RE: Revised manuscript gmd-2020-330

On behalf of the co-authors, I hereby submit a revised version of the manuscript entitled “Quantifying and attributing time step sensitivities in present-day climate simulations conducted with EAMv1” (MS No.: gmd-2020-330).

Referee #1's Comments and the Author's Responses and Changes in Manuscript

Figure 1: An example of the old (left panel) and new (right panel) schematics included in the manuscript.

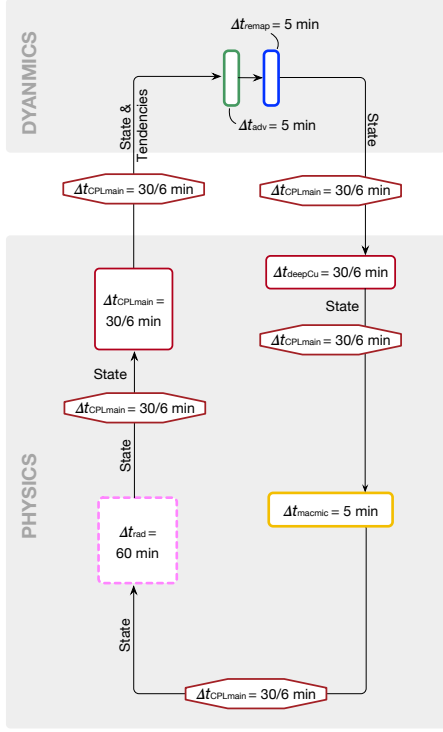
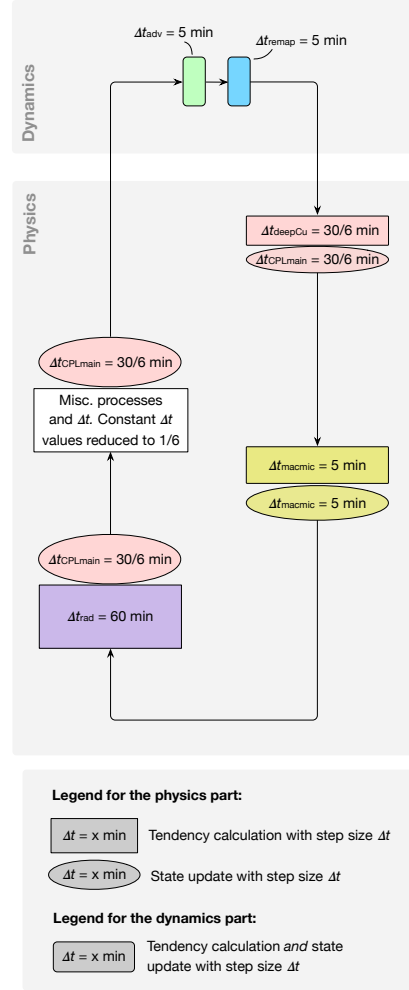
Referee comment: 2) Figure 1: This is a useful schematic to quickly capture the timestepping process. I’m not sure I can see from this where/when the state is updated though. Is it at every point where State is labelled? Could this be made a bit clearer?

Author’s response and changes in manuscript: Thanks for asking about this. We have revised all schematics in the manuscript to explicitly depict where/when the model state is updated. The figure on the next page shows an example of how the old (left panel) and new (right panel) schematics look like. We also added a clarification in Section 2.1 (see page 4, lines 97–99 of the marked-up version):

“(In Figure 2 and additional schematics presented later in the paper, tendency calculations in the physics part are depicted by rectangular boxes with sharp corners while the update of model state is shown by oval shapes.)”
